ADDENDUM NO. 07

9 June 2009

Project: **THE NEW TEXAS CITY HIGH SCHOOL**
Texas City Independent School District

Bay Project No.: **0748**

SCALE: N.T.S.	ADDENDUM# 07-02
DATE: 06/09/09	SHEET NO.: C2.29

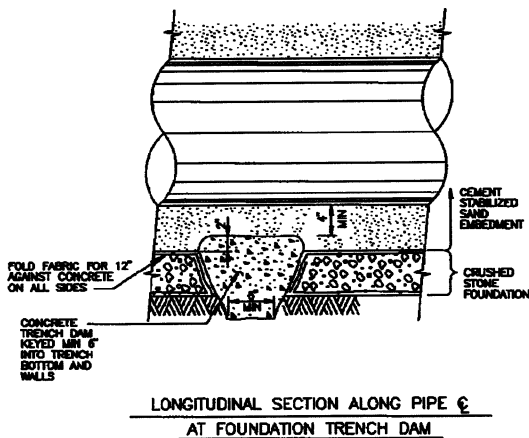
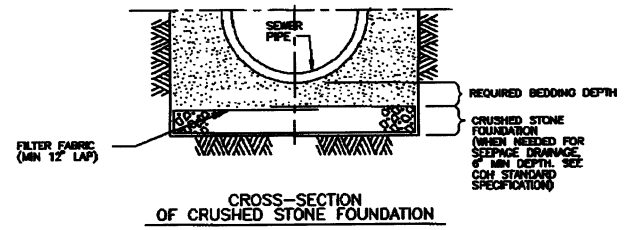
7. Sheet C2.01. Add Notes 12 and 13 to “Sanitary Sewer Construction Notes”. Notes 12 and 13 describe additional wet soil construction. See Sketch **ADD-07-01**.
8. Sheet C2.29. Add sanitary sewer wet trench construction detail. See Sketch **ADD-07-02**.
9. Sheet C2.29A. New Sheet. Add corrosion resistant manhole detail. See Sketch **ADD-07-03**.
10. Sheet C2.29A. New Sheet. Add seal slab and pile detail for sanitary sewer lift station wet soil conditions. See Sketch **ADD-07-04**.

**SANITARY OR STORM SEWER
 CRUSHED STONE FOUNDATION
 FOR WET STABLE TRENCH**

ADDENDUM#
07-04

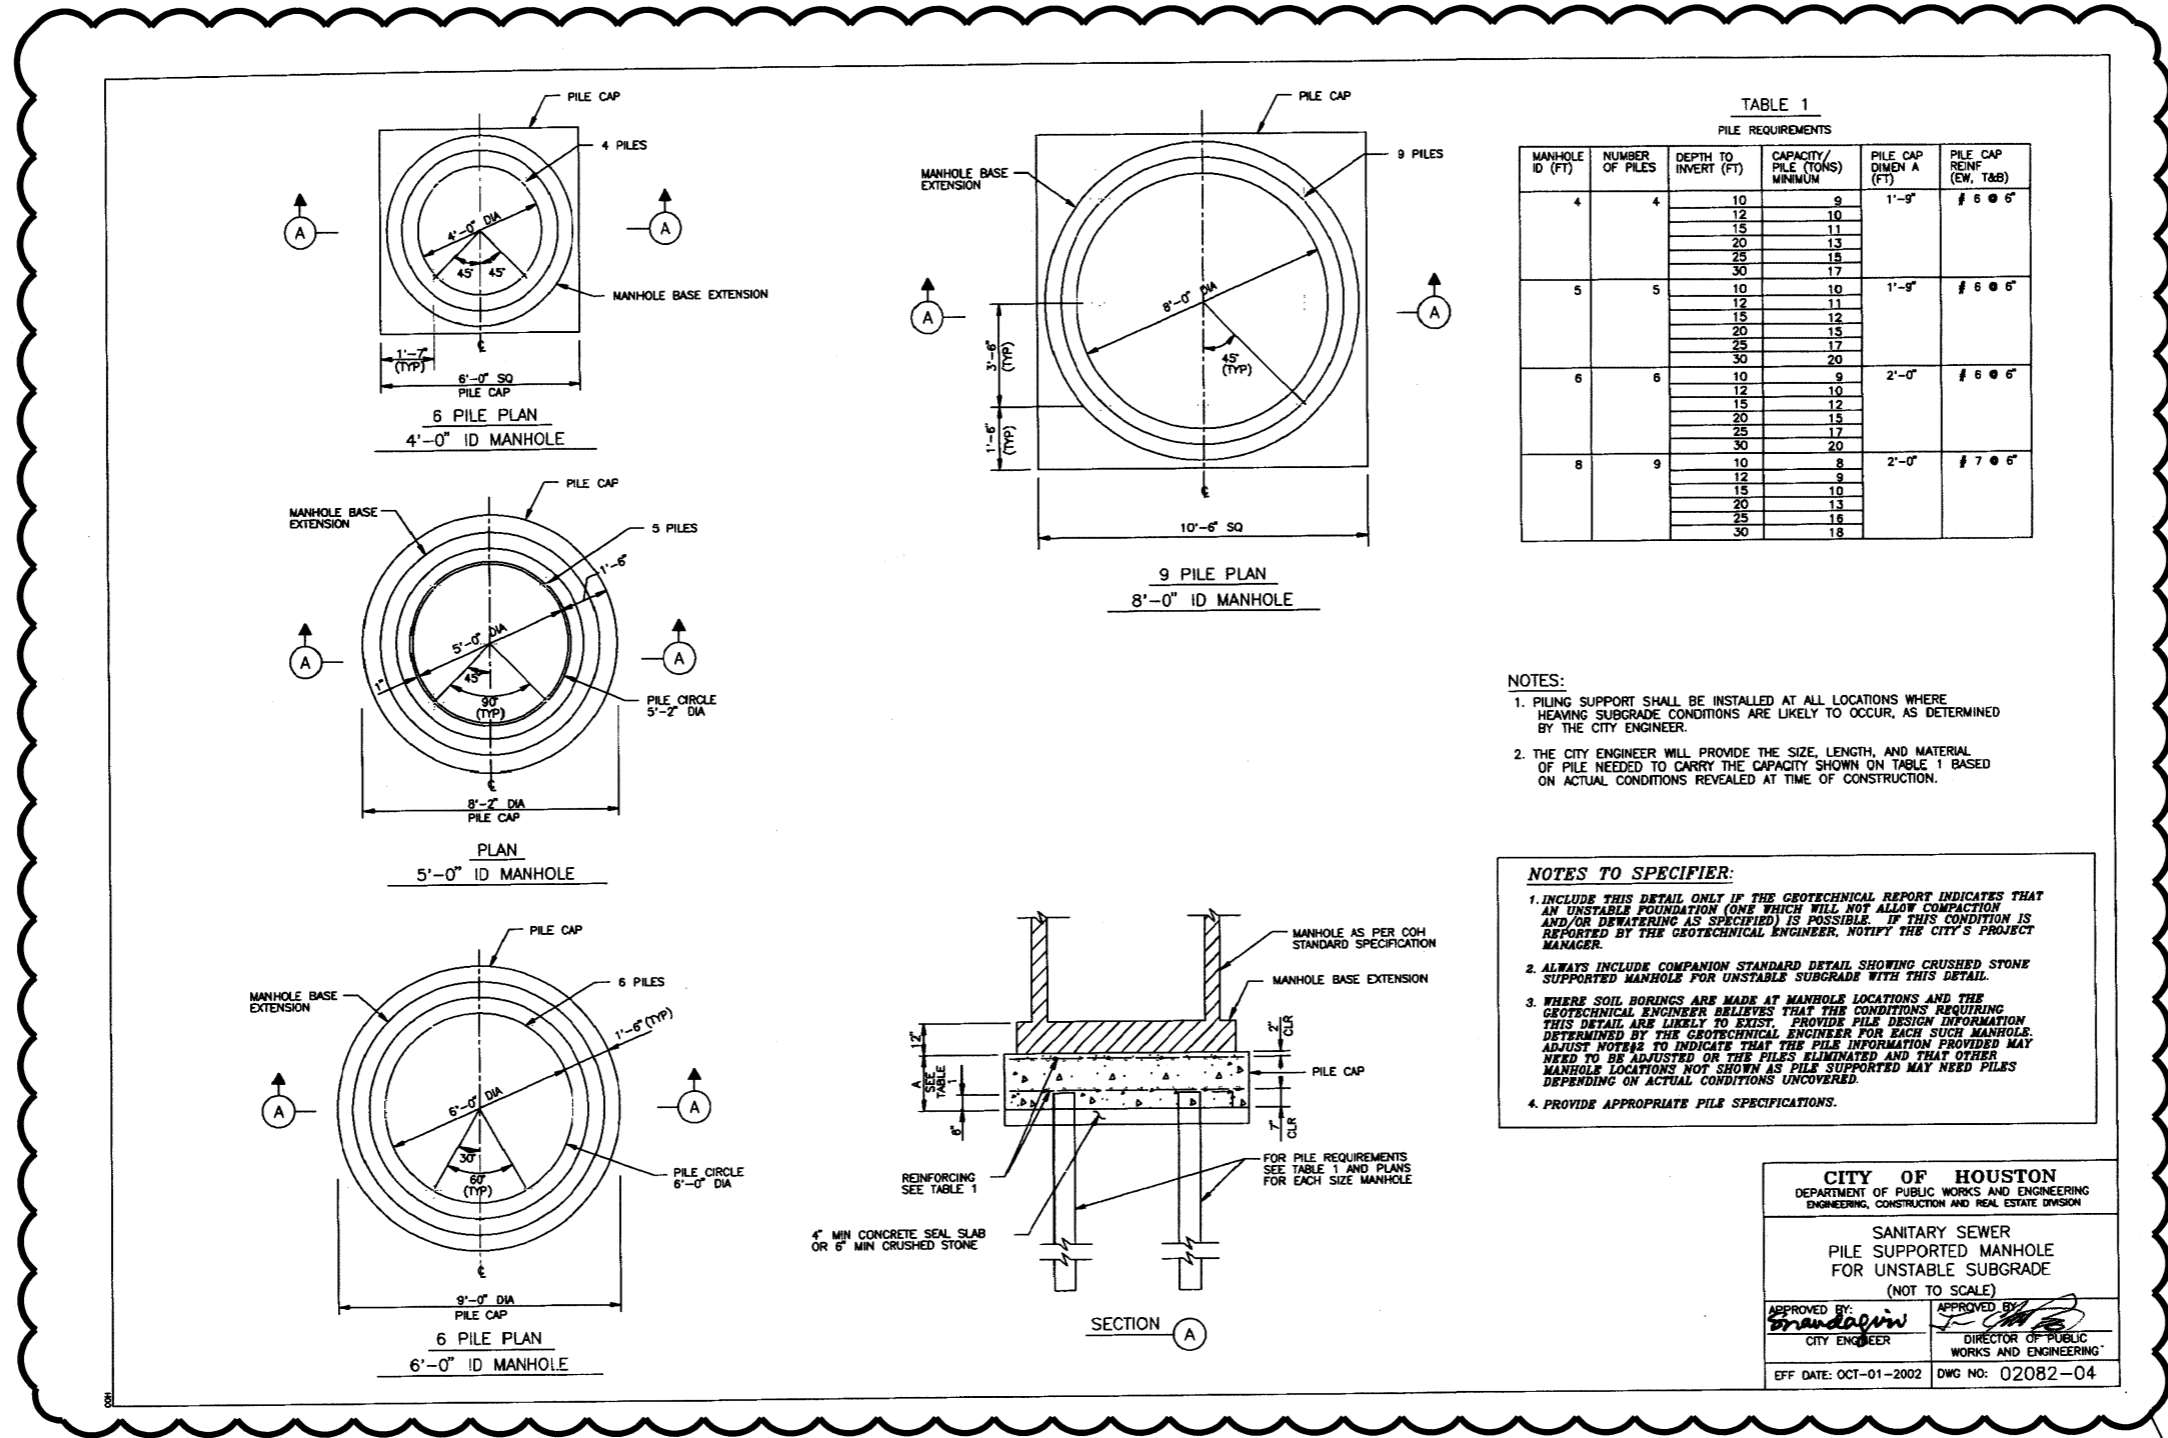
13. WET SOIL CONDITIONS MAY AFFECT CONSTRUCTION AND INSTALLATION OF PROPOSED SANITARY SEWER LIFT STATION. CONTRACTOR TO PROVIDE A LUMP SUM COST TO PROVIDE THE FOLLOWING: 2' THICK SEAL SLAB AND PILES PER CITY OF HOUSTON DETAIL 02082-04 (DETAIL PROVIDED IN ADDENDUM #7 SKETCH ADD-07-04), WELL POINTING AND TRENCH SAFETY (TRENCH BOXES) FOR EXCAVATION AND ONE (1) SOIL BORING TO A 30 FOOT DEPTH AND GEOTECHNICAL ENGINEER RECOMMENDATION FOR PILES. USE THE 8' DIAMETER MANHOLE REQUIREMENTS ON DETAIL 02082-04. CONTRACTOR TO COORDINATE SOIL BORING AND GEOTECHNICAL RECOMMENDATION ON PILES AFTER BUILDINGS ARE DEMOLISHED AND BORING CAN BE PERFORMED AT EXACT LIFT STATION LOCATION.

SANITARY SEWER
 PILE SUPPORTED MANHOLE
 FOR UNSTABLE SUBGRADE
 (NOT TO SCALE)
